### APPEAL SUMMARY

<b>Appeal ID:</b> 23399	<b>Project Address:</b> 4451 NE 42nd Ave
<b>Hearing Date:</b> 2/5/20	<b>Appellant Name:</b> Melissa Meiners
<b>Case No.:</b> B-003	<b>Appellant Phone:</b> 503 708-2157
<b>Appeal Type:</b> Building	<b>Plans Examiner/Inspector:</b> Steven Mortensen
<b>Project Type:</b> commercial	<b>Stories:</b> 3 <b>Occupancy:</b> R-2 <b>Construction Type:</b> V-B
<b>Building/Business Name:</b> Society 42	<b>Fire Sprinklers:</b> Yes - Throughout Building
<b>Appeal Involves:</b> Erection of a new structure	<b>LUR or Permit Application No.:</b> 19-247186-CO
<b>Plan Submitted Option:</b> pdf [File 1]	<b>Proposed use:</b> Apartments

SOCIETY 42

3/ PRIVACY FENCE ELEVATIONS

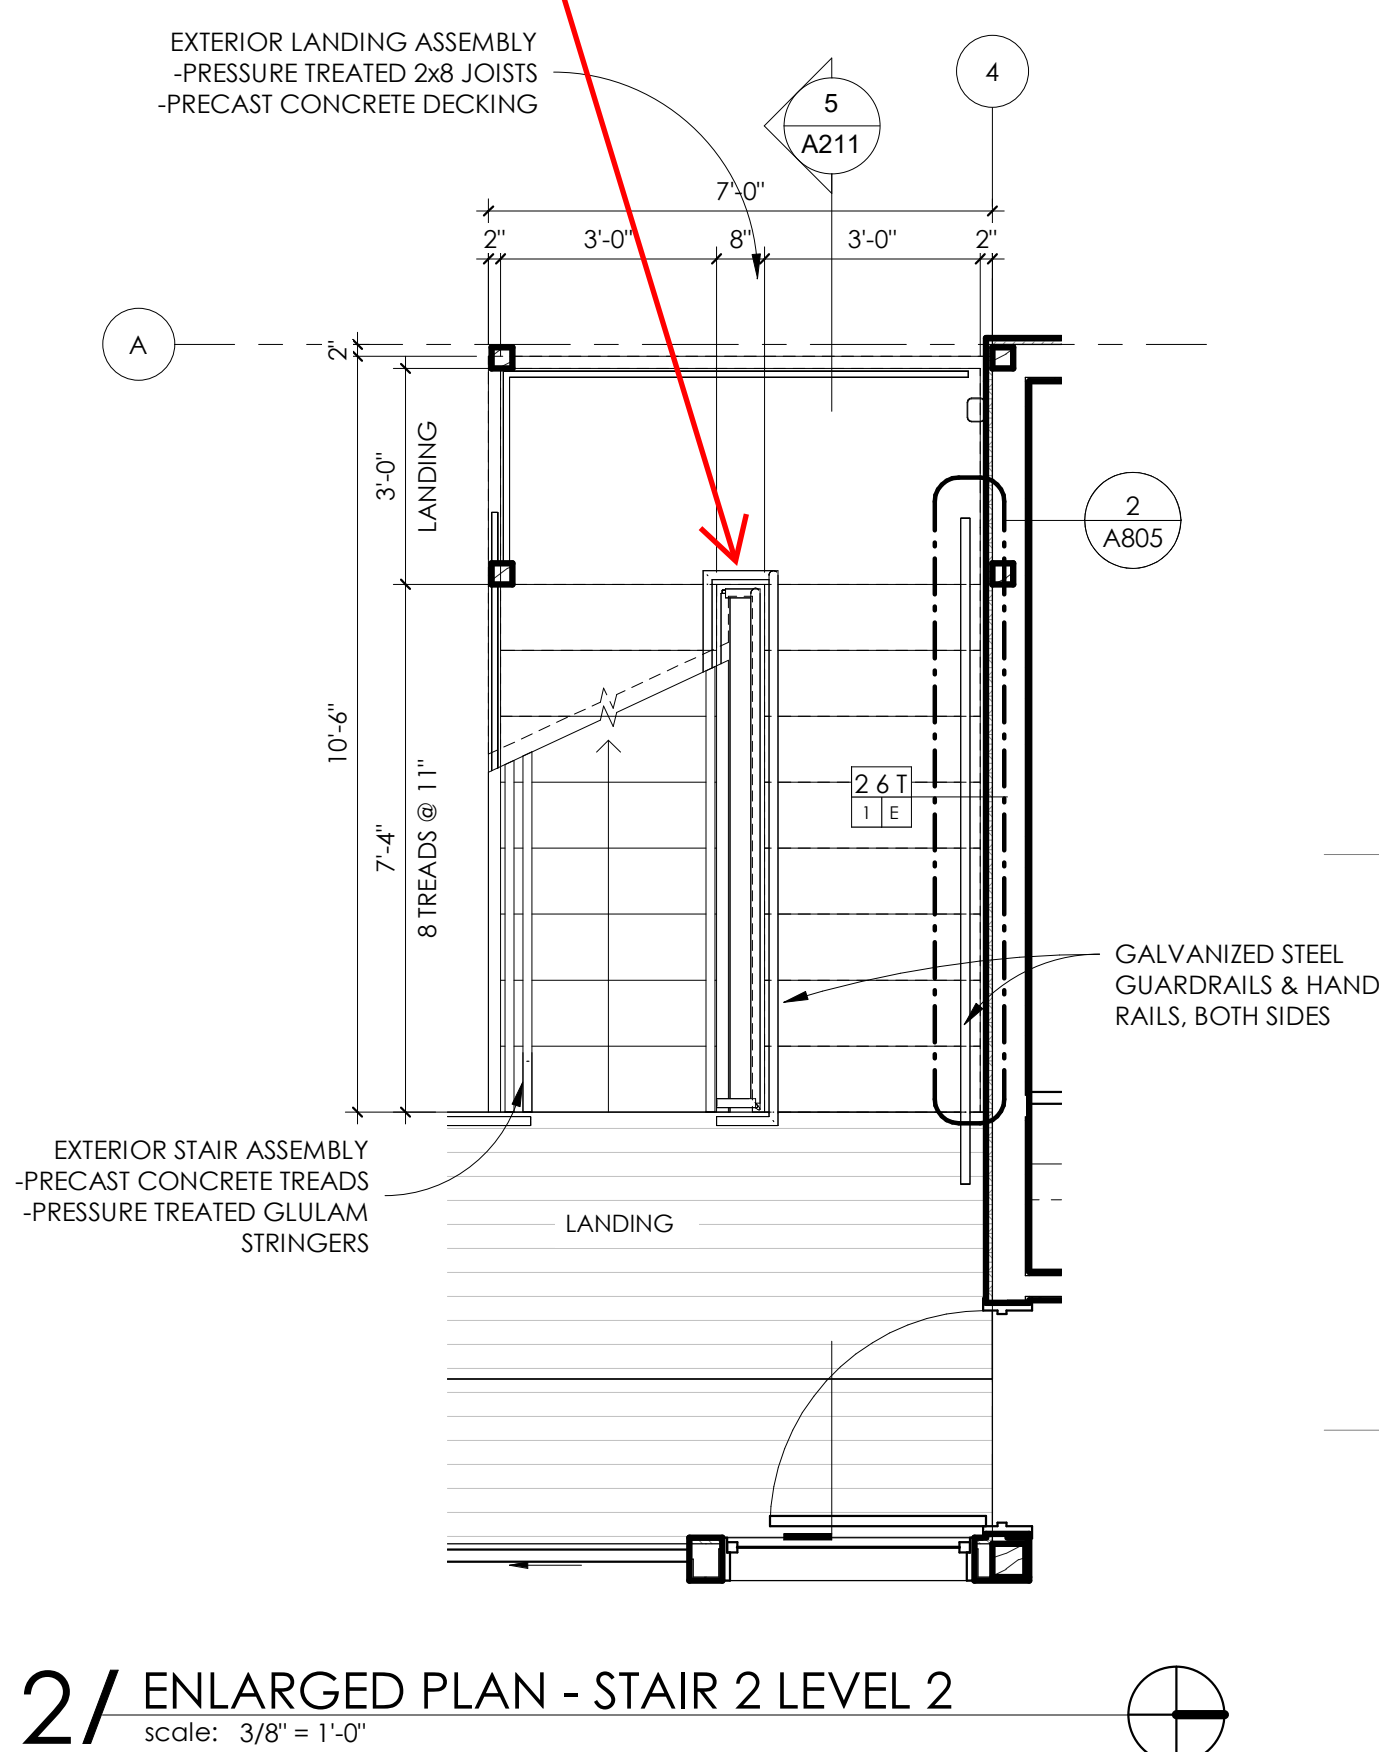
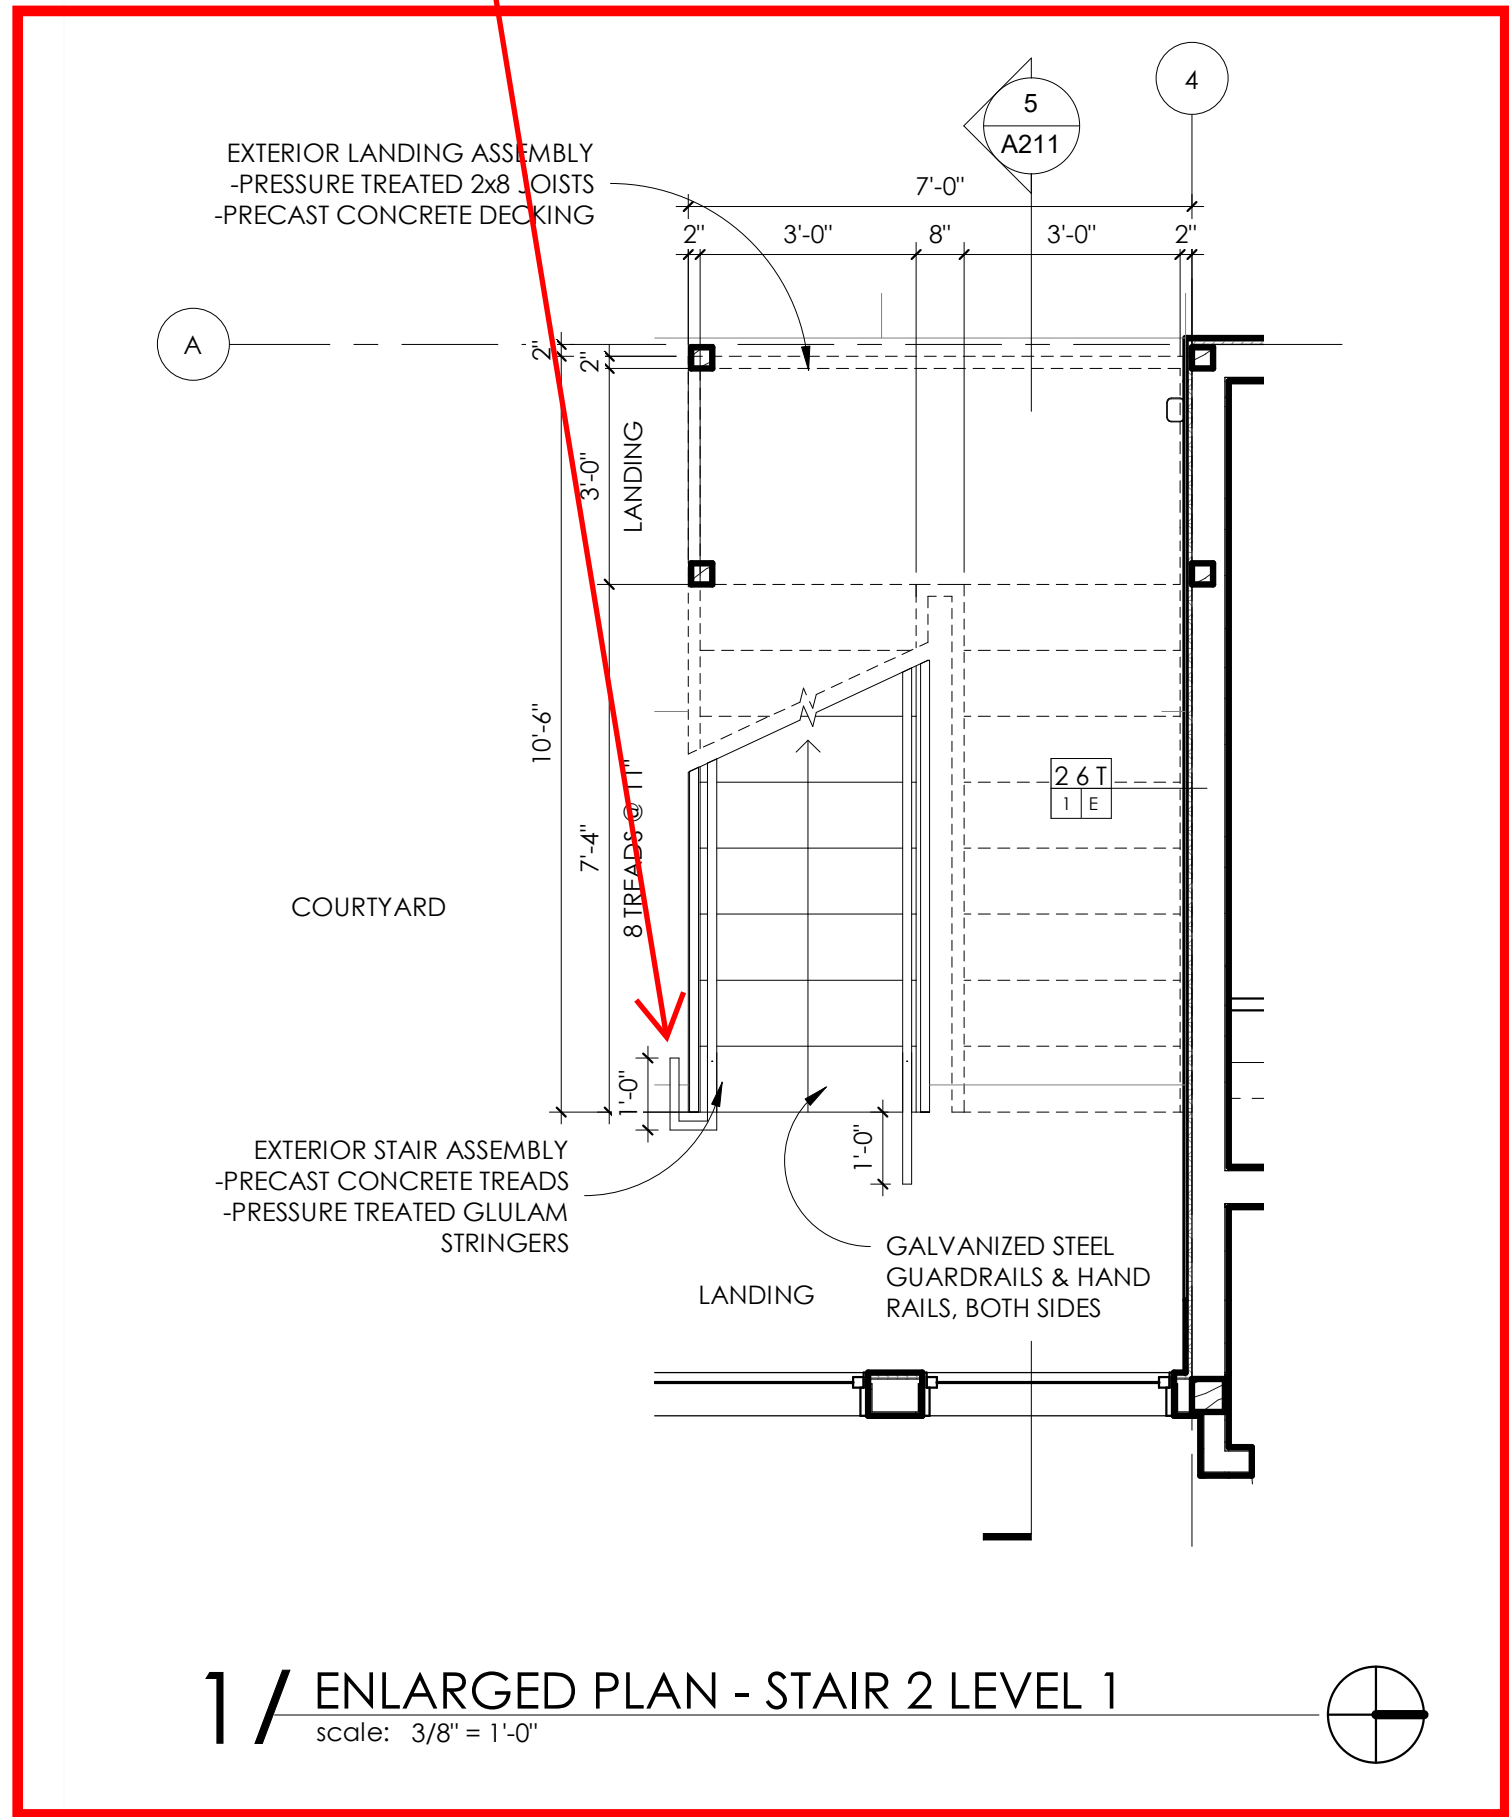
<b>Reason for alternative</b>	<p>Exterior Exit Stairway #2 – The south handrail extension at the bottom riser of this stair is proposed to turn 180 degrees, in the same way handrails return at the continuous inner handrails between flights of stairs. This will alleviate the pinch point at grade between the handrail and building wall. Turning the handrail extension 180 degrees will also lead occupants around the stairs and towards the egress court when exiting.</p> <p>North Exterior Stair #4 - The straight, continuous 12" extension would extend into the ROW and require an encroachment permit from PBOT. The handrails still provide a continuous gripping surface that lead building occupants to grade when exiting.</p> <p>Similar appeals have been granted. See appeals #18642, 18187, 18922 and 18798.</p> <p>The applicant requests that the handrail extension for the Exterior Exit Stairway #2 be permitted to turn 180 degrees.</p> <p>The applicant requests that the handrail extensions for the North exterior stair #4 be permitted to turn 90 degrees.</p>

APPEAL ITEM 3 -  
HANDRAIL EXTENSION TURNS 180 DEGREES.  
SIMILAR CONDITION TO INNER HANDRAIL

**3a. Omission of full 12 inch horizontal handrail extension: Denied. Proposal does not provide equivalent Life Safety protection.**

**3b. Stair 2 bottom handrail extension to wrap 180 degrees: Granted as proposed.**
